ABINGTON TOWNSHIP

PLANNING COMMISSION MEETING

a. Review the Final Major Land Development application LD-23-01 for the location at 711 Fox Chase Road, Jenkintown, PA 19046. (St. Basils).

DATE: 3-24-23	SCALE: 1" = 30'
DESIGN:	DRAWN: EJS
JOB NO.: 7662	FILE NAME: 7662-S-05-GRADE
REF. NO.: **SD05.01**	
SHEET NO.: **12** OF **62**

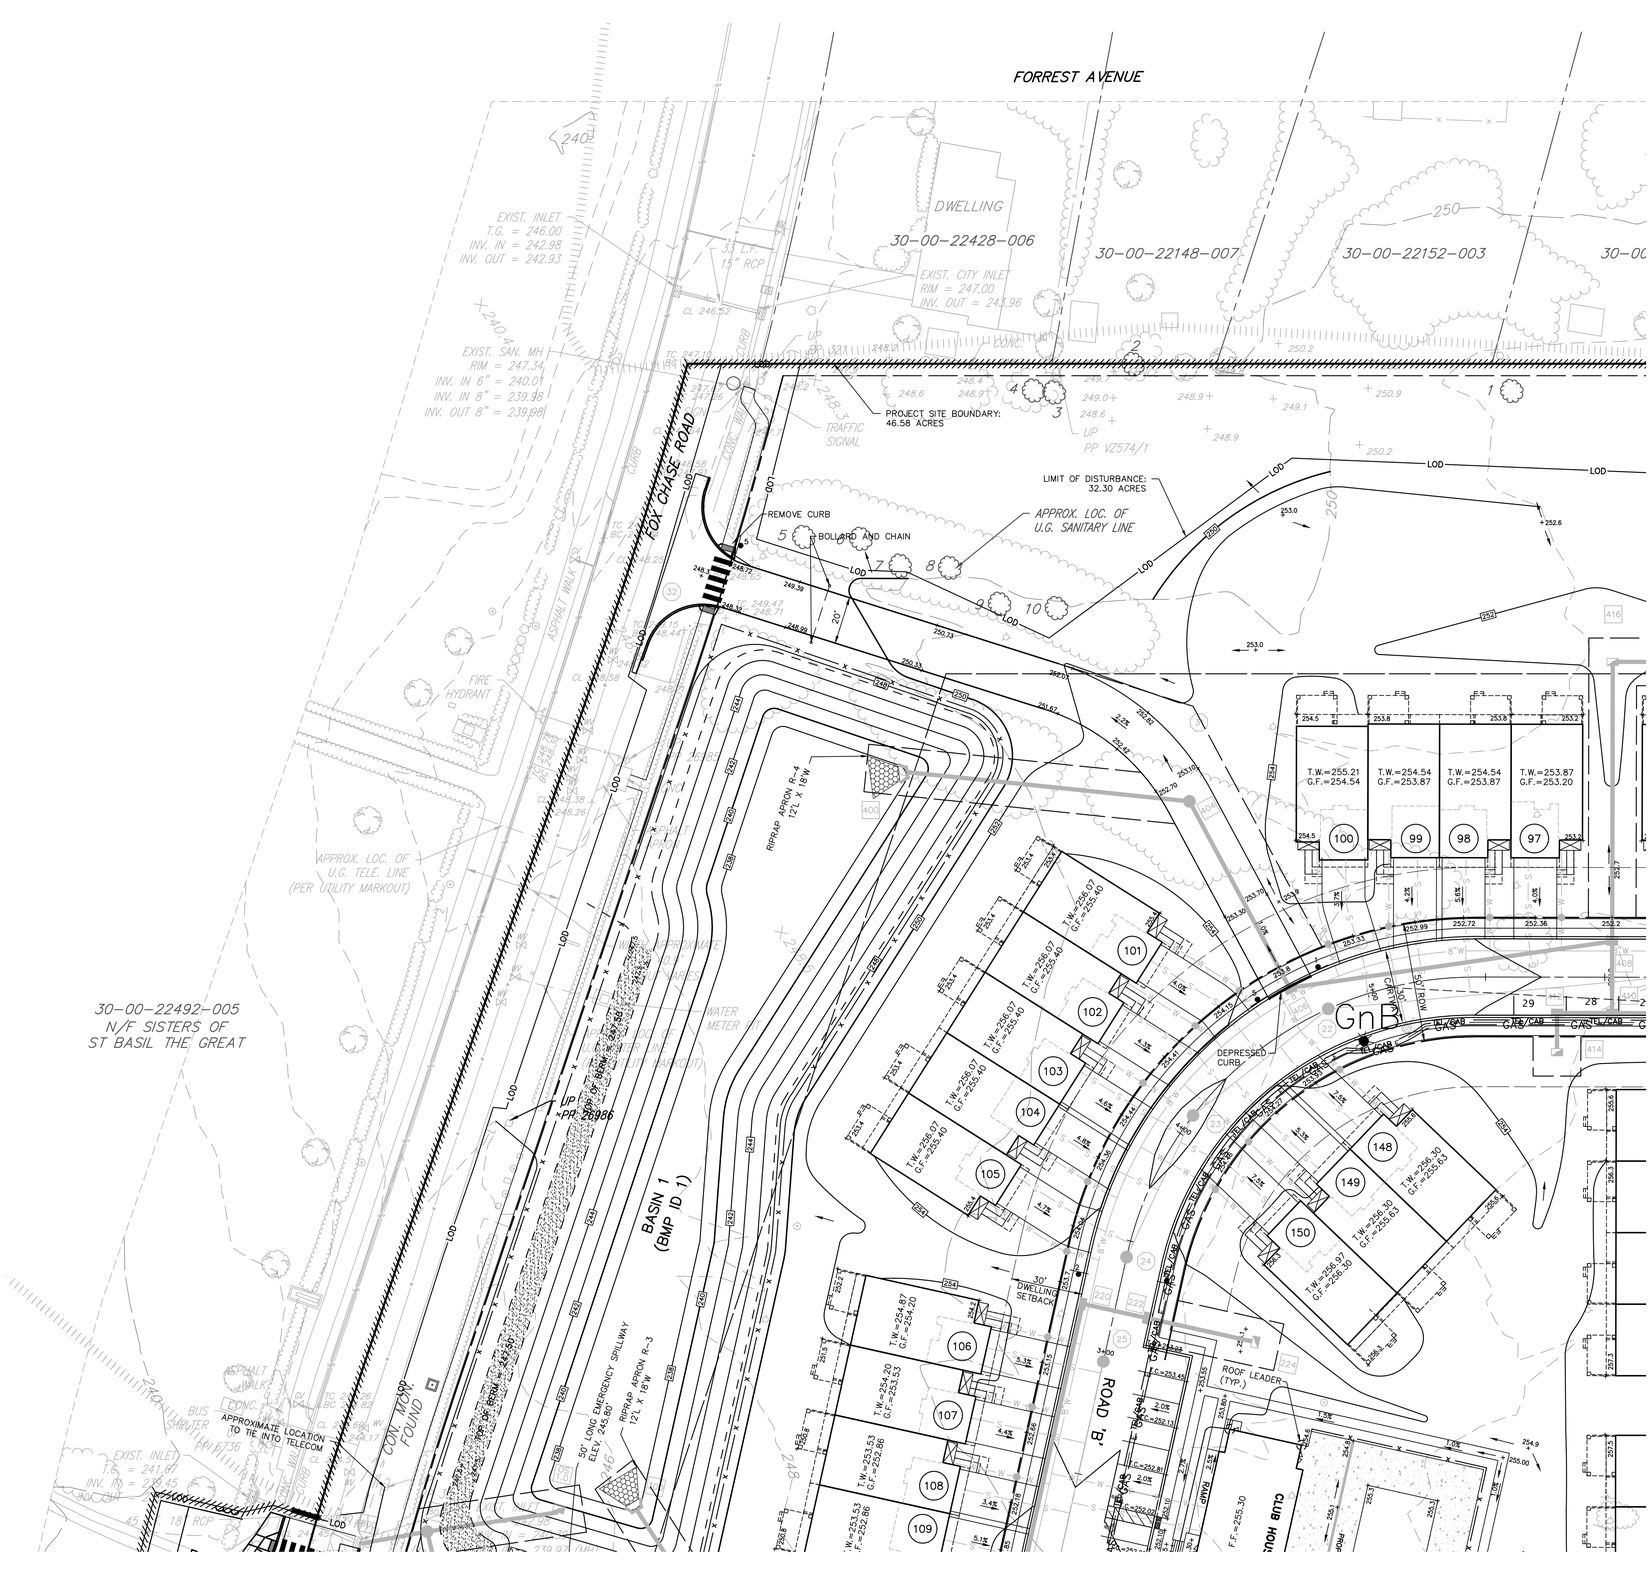
A detail of the proposed emergency access chain and bollards is provided on the Construction Details Plan (Sheet 41); however, the chain and bollard does not appear to be shown on the plans. The Applicant shall show the location of the chain and bollard for the proposed emergency access. The Applicant should provide no parking signs at the entrances to the emergency access in addition to the proposed "No Parking" sign located adjacent to Unit 100.

ESE Response: The applicant has updated sheet 12, SD05.01, with the bollard and chain object and callout. The bollard and chain is located along the Access Road connecting Fox Chase Road with Road B. Additionally, a "No Parking Sign" sign (Sign No. 5 in the Sheet 12 Legend) has been placed at the entrance along Fox Chase Road and internally along Road B. Lastly, the applicant has added a "Do Not Enter" sign (Sign No. 1 in the Sheet 12 Legend) along Road B and next to Unit 100.
